KWM-380 TRANSCEIVER (622-5093-101)
HF-380 TRANSCEIVER (622-3580-101)
RECEIVER-EXCITER CIRCUIT CARD A3 (638-6908-001)

SERVICE BULLETIN NO 1**PRODUCT IMPROVEMENT**

This is a nonmandatory service bulletin which applies to the following:

P/O Control Card A8
Figure 1

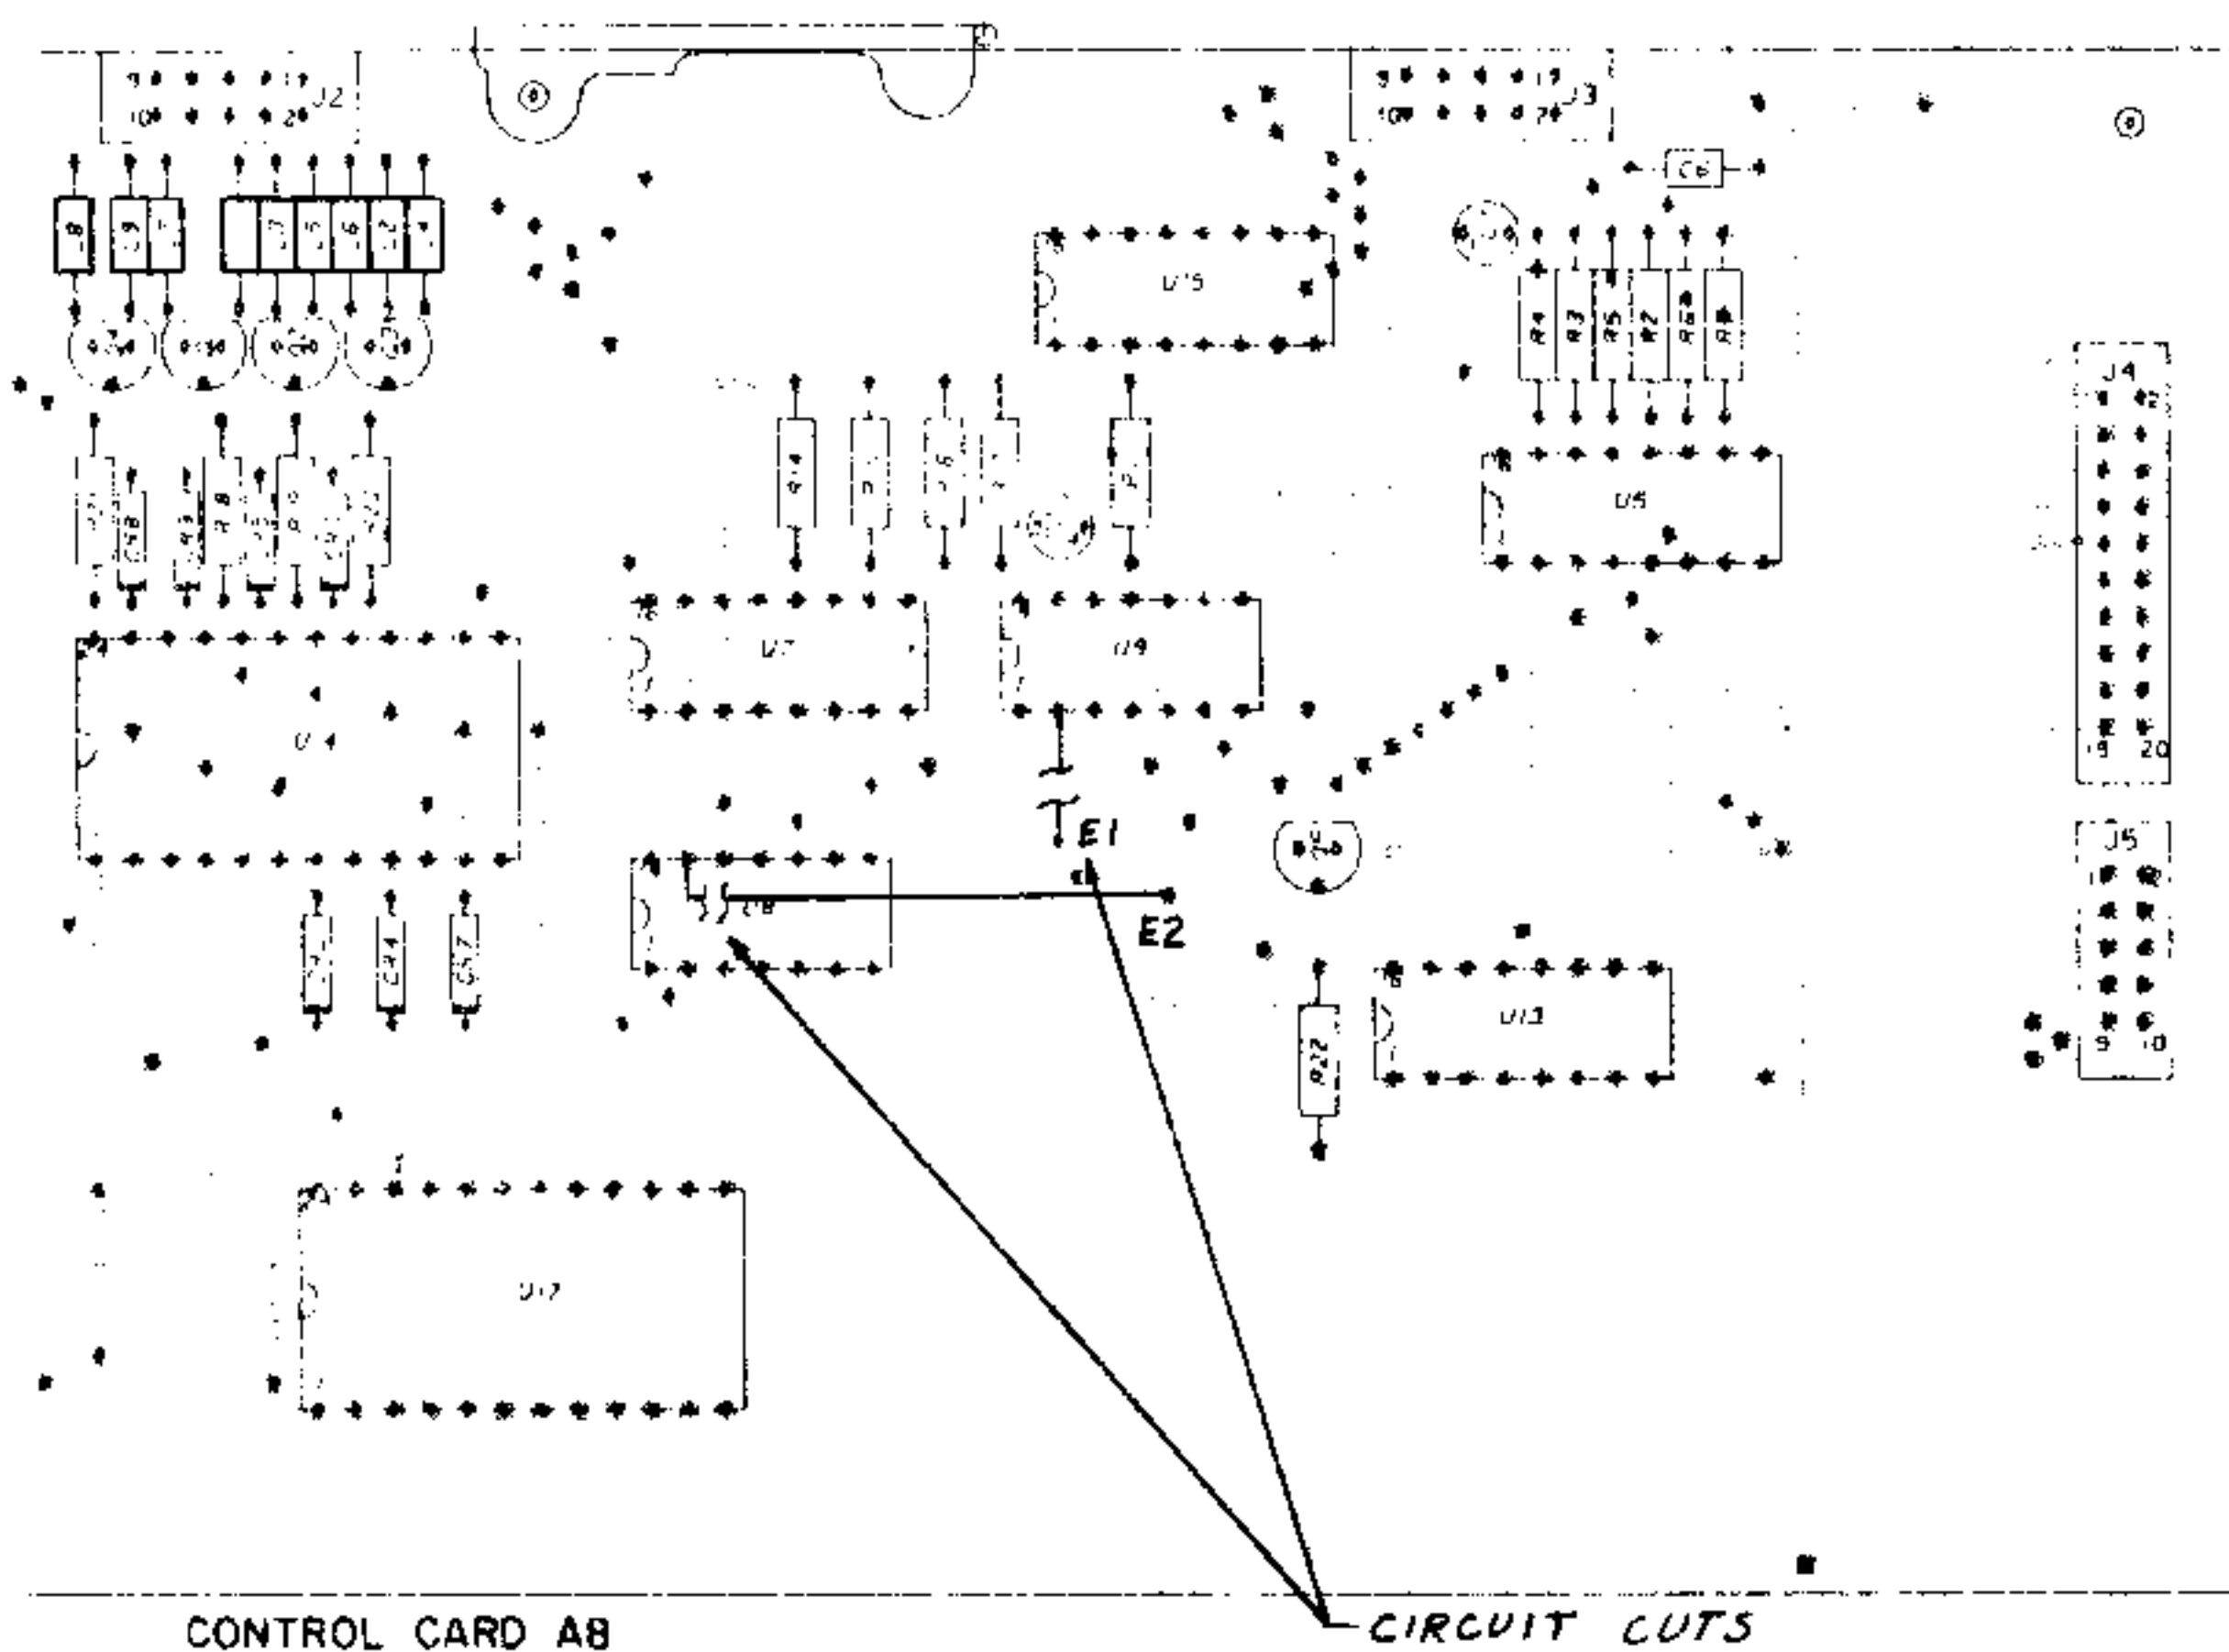
- E. Remove 100- μ H coils L1 through L9 and replace them with 560- μ H coils (240-2723-050).
- F. Cut the circuit trace from U9-2 to E1.
- G. Cut the circuit trace from U8-13 to E2.
- H. On the bottom of the card, install a jumper wire (422-2400-020) from E1 to U9-4.
- I. On the bottom of the card, install a jumper wire (422-2400-020) from E2 to U8-12.
- J. Install two cable clamps (150-0873-010) in the synthesizer compartment as shown in figure 2.
- K. Route the two cables on the back of the synthesizer assembly through the cable clamps and out the end of the card cage. This will hold the cables away from the circuit card components.
- L. Reassemble the transceiver in the reverse order of disassembly.

P/O Receiver/Exciter A3, Component Installation Diagram
Figure 1 (Sheet 1 of 2)

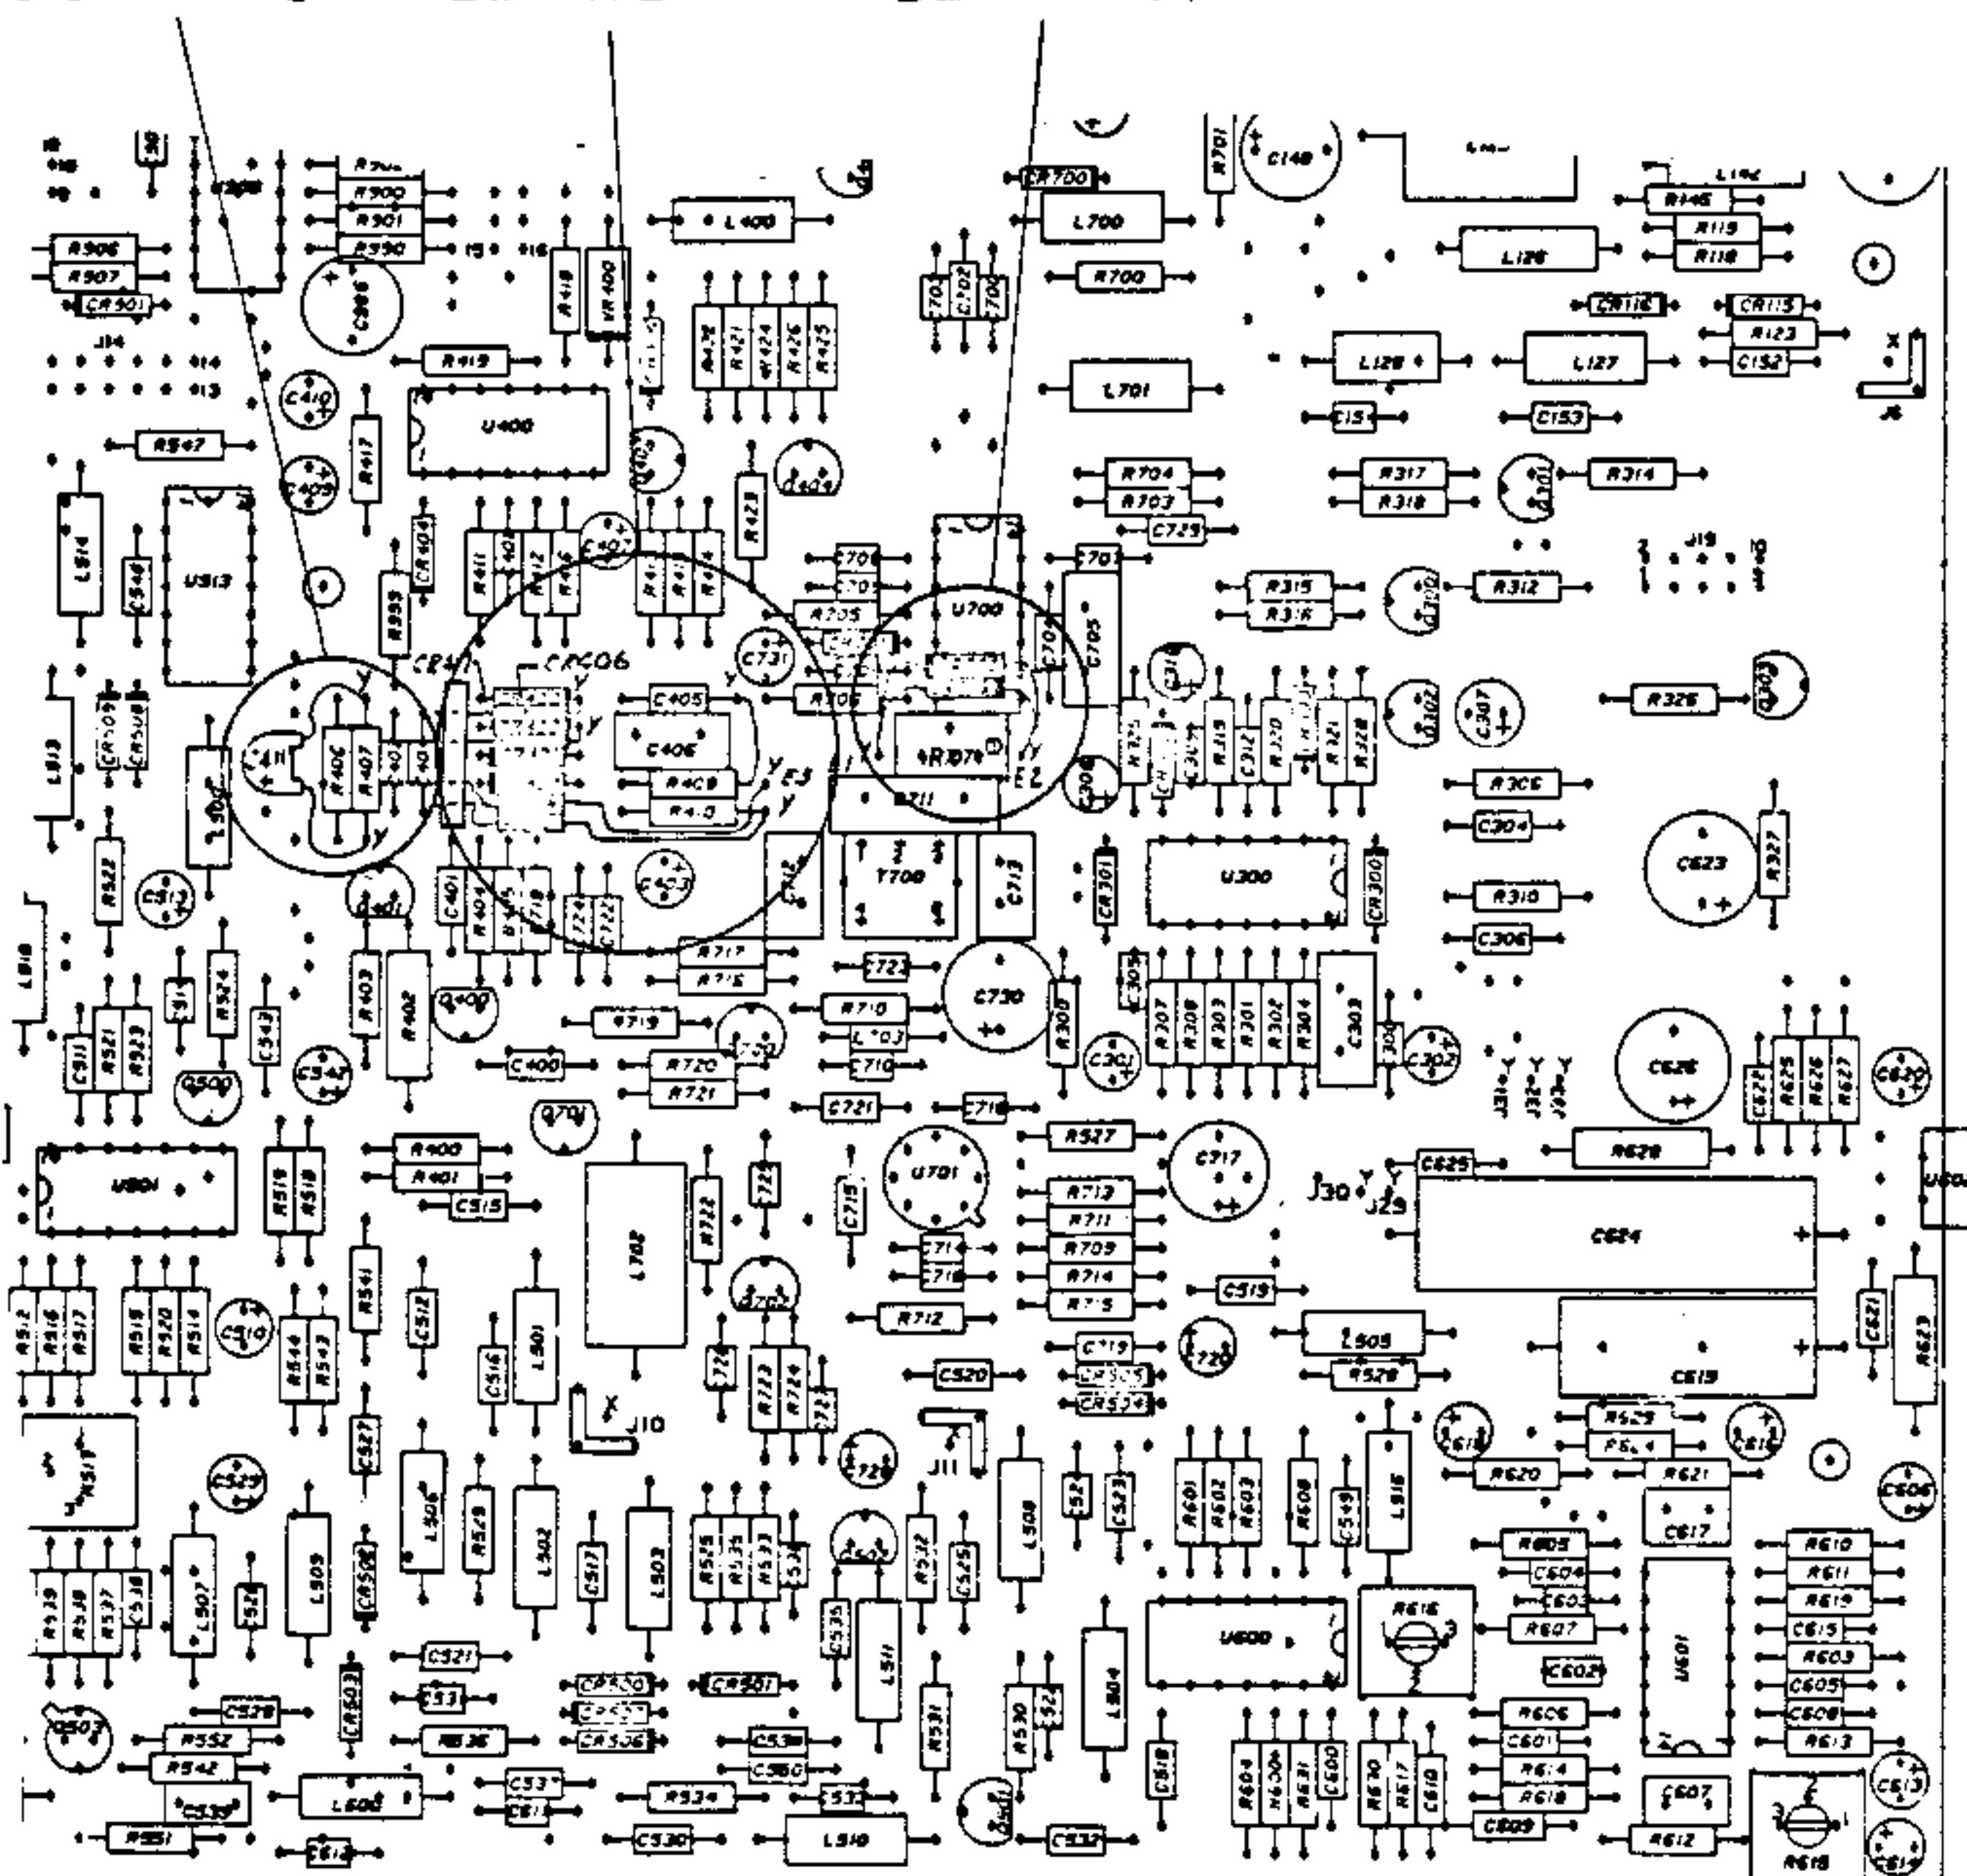
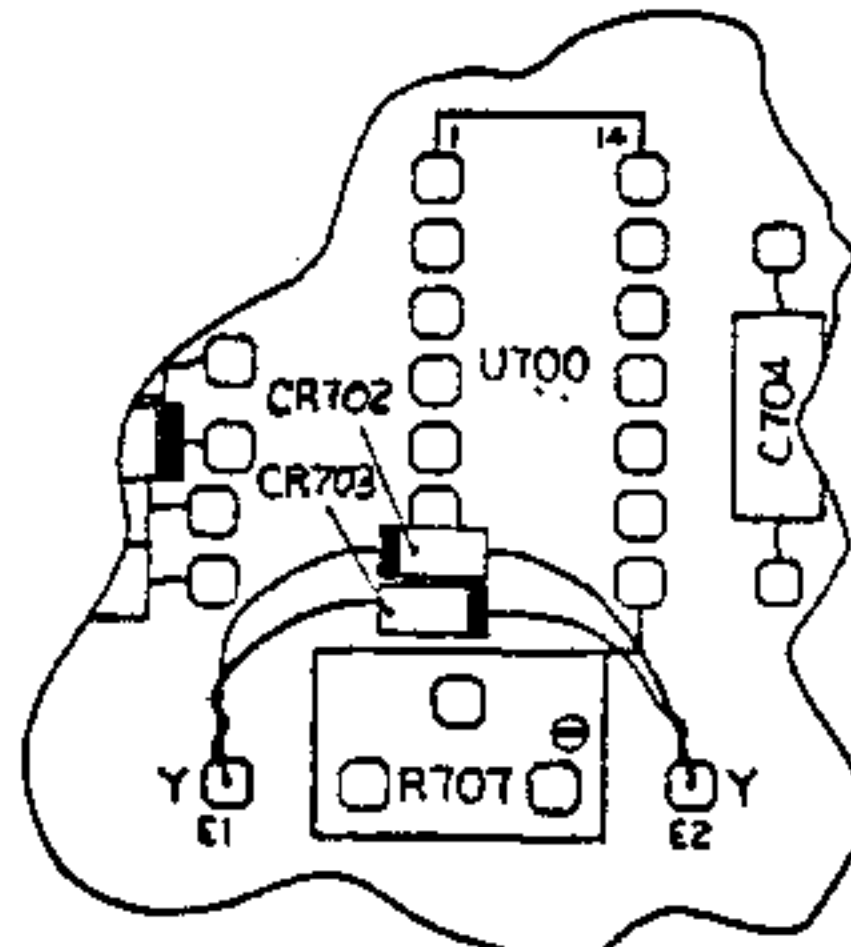
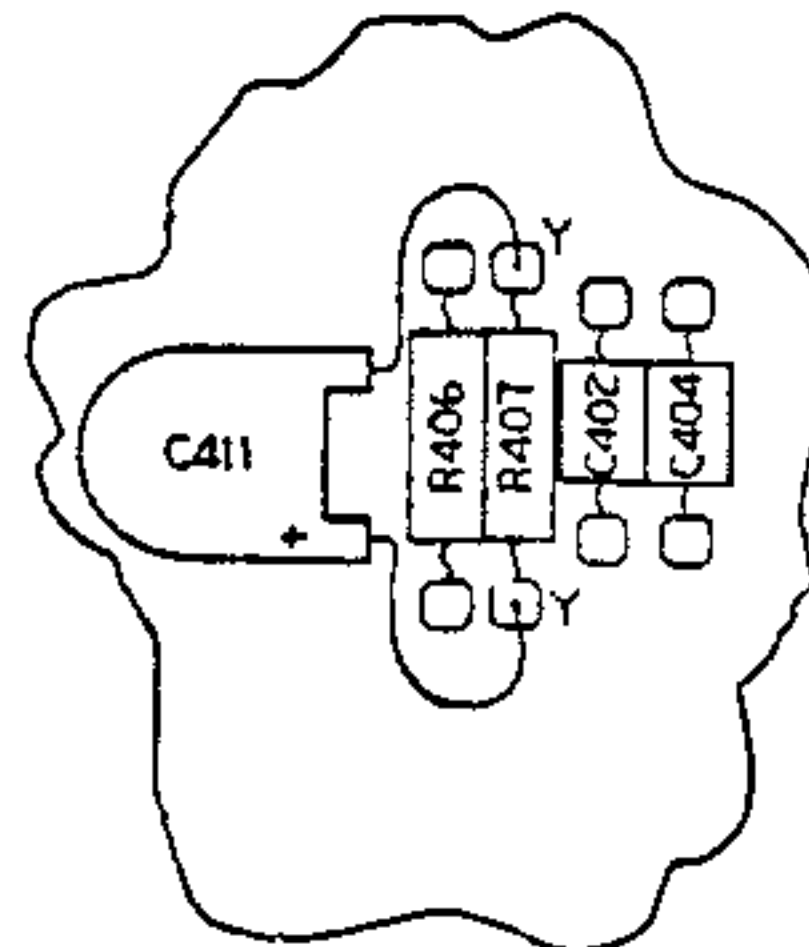
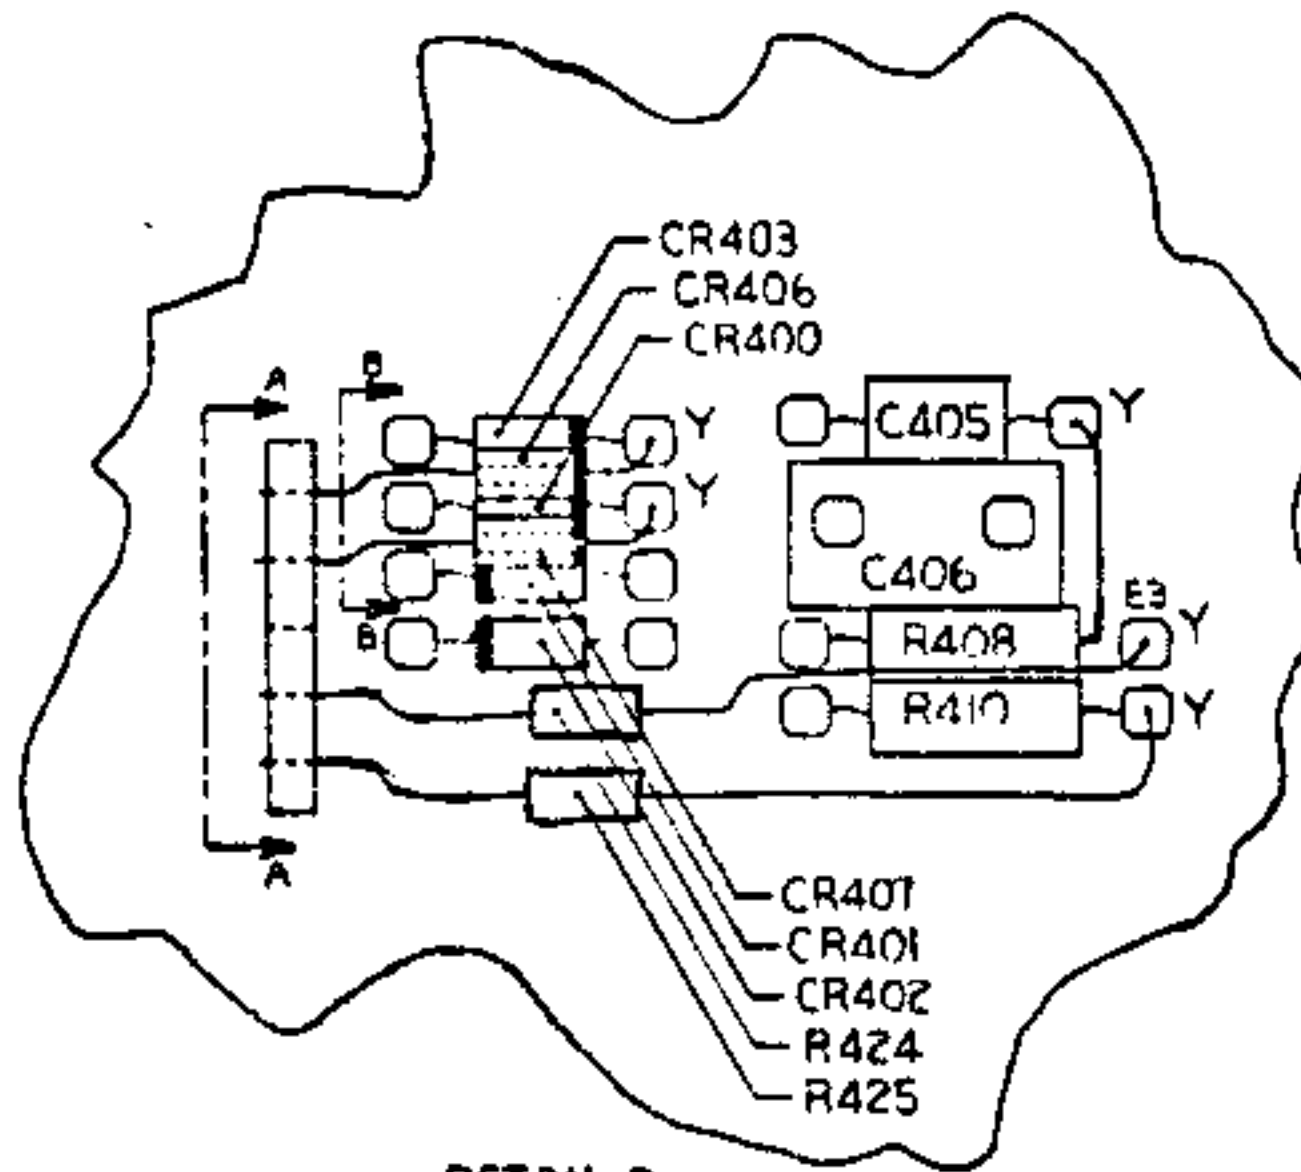
- C. Install contacts, 372-2656-130 (square pins) at E1 and E2 (holes in board) and solder. Refer to figure 1, detail A.
- D. Install 1N4454 diode CR702 (353-3644-010) with cathode to E1 as shown in figure 1, detail A.
- E. Install 1N4454 diode CR703 (353-3644-010) with cathode to E2 as shown in figure 1, detail A.

- F. Remove both leads of resistor R407 and install a contact (372-2656-130) in each hole.
- G. Connect the R407 leads to the new contacts.
- H. Install 100- μ F capacitor C411 (184-9102-100) to the new contacts with the positive side to the bottom of R407 as shown in figure 1, detail C.

- K. Position 1N4454 diode CR406 (353-3644-010) as shown in figure 1, detail B, section BB. Connect the cathode end to the contact installed in step I.

- L. Position 1N4454 diode CR407 (353-3644-010) as shown in figure 1, detail B, section BB. Connect the cathode end to the contact installed in step J.

- S. Cut a terminal strip (797-3615-001) into one block of five holes.
- T. Position the terminal block as shown in figure 1, detail B, and secure it to the circuit card using commercially available epoxy or bonding adhesive.
